Editor's Report 60802 Draft 1.2

**November, 2020
IEEE802 Virtual Plenary**

Figure 1 – Isochronous network Access

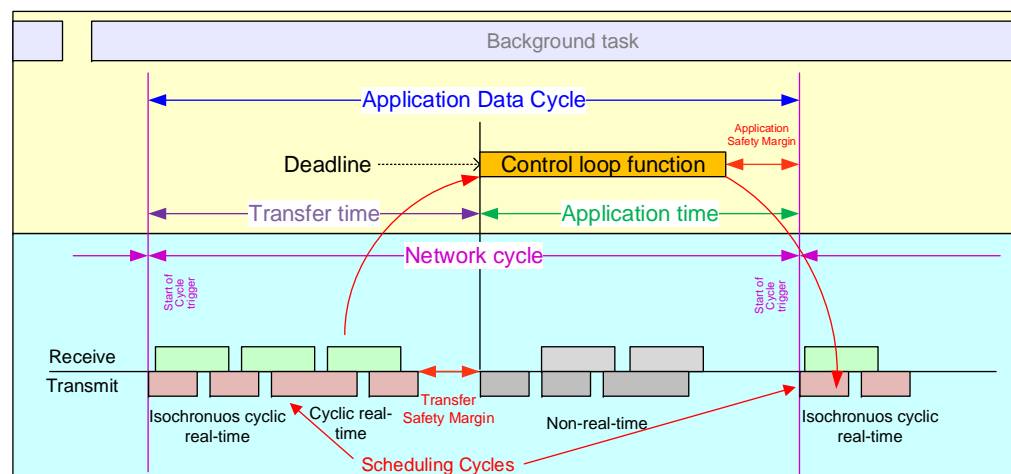
- These definitions are strongly related to the text and figures in subclause 4.3 and are the subject of discussions in the system ad hoc. The editor suggests waiting for the outcome of those discussions before attempting to resolve the comments
